Charlotte Historic District Commission

Application for a Certificate of Appropriateness August 10, 2011

ADDRESS OF PROPERTY	1621 Dilworth Road East, Dilworth Local Historic District	HDC 2011-080
SUMMARY OF REQUEST	Entrance Step Replacement – St. Patrick’s Cathedral	
OWNER	Catholic Diocese of Charlotte – The Most Reverend Bishop Peter J. Jurgis, JCD	
APPLICANT	John Phares

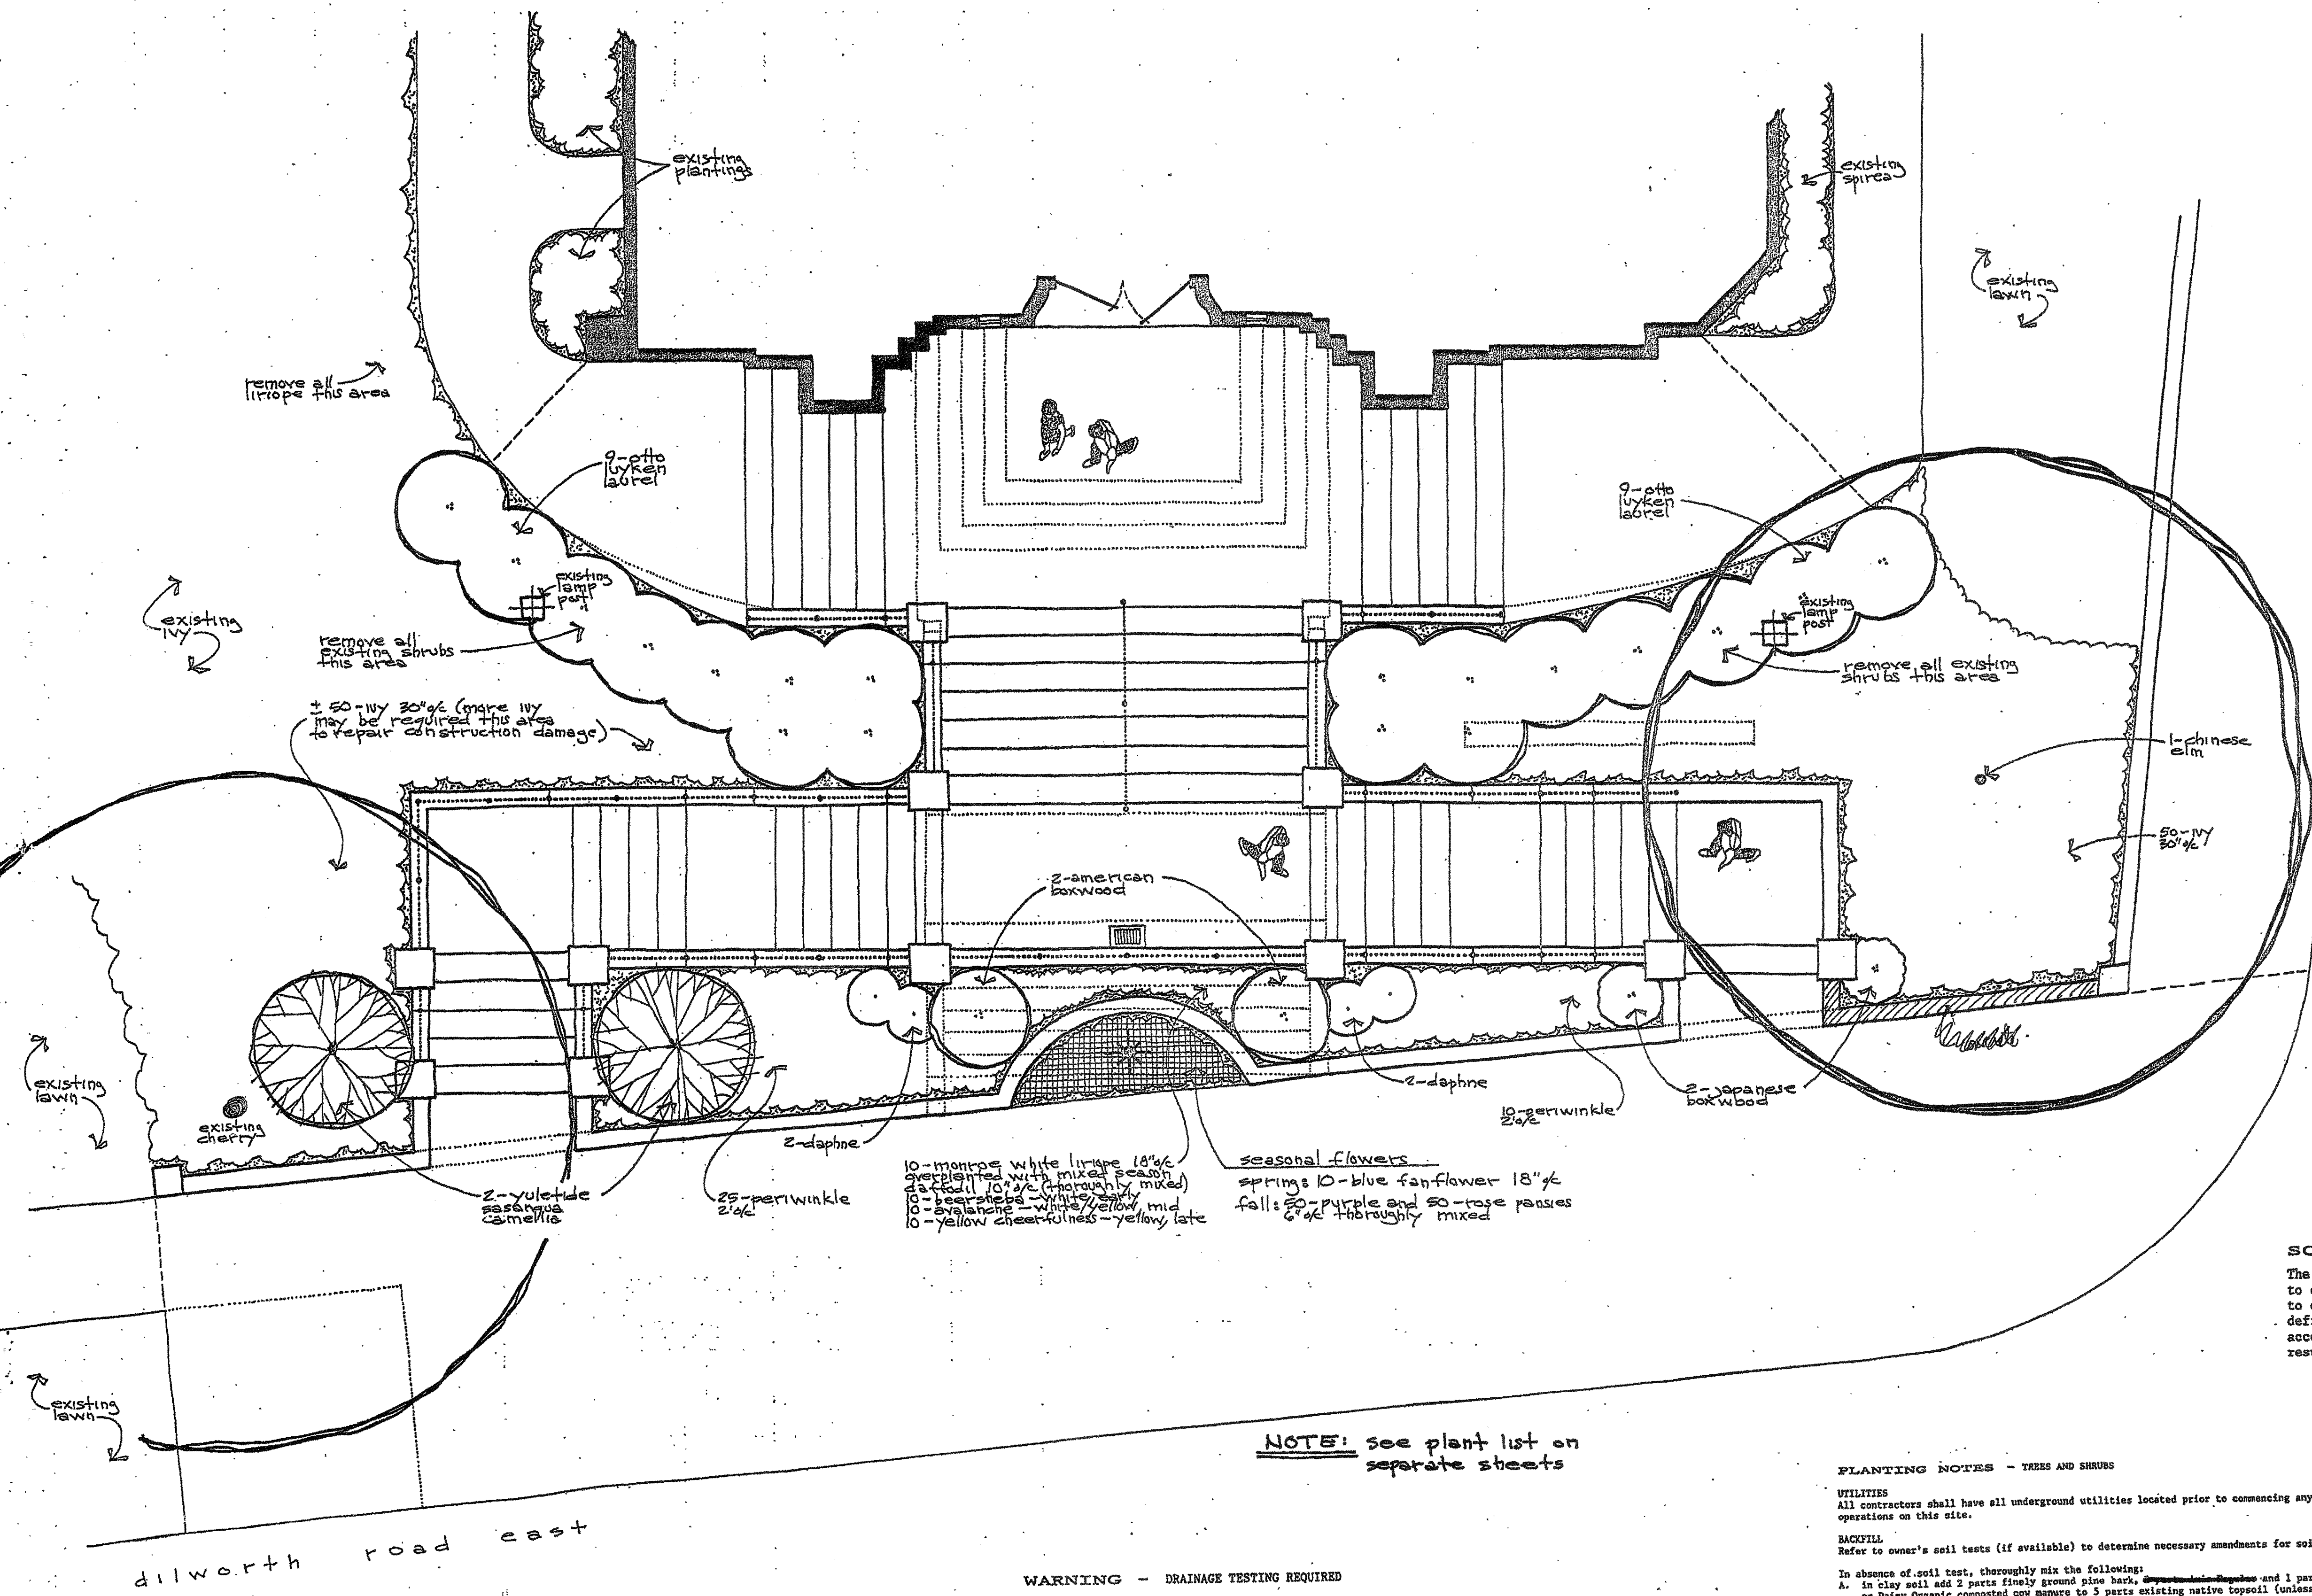
The plan also includes planters at the sidewalk level, and a landscaping plan is attached. This element would mitigate any streetscape impact this proposal would have.
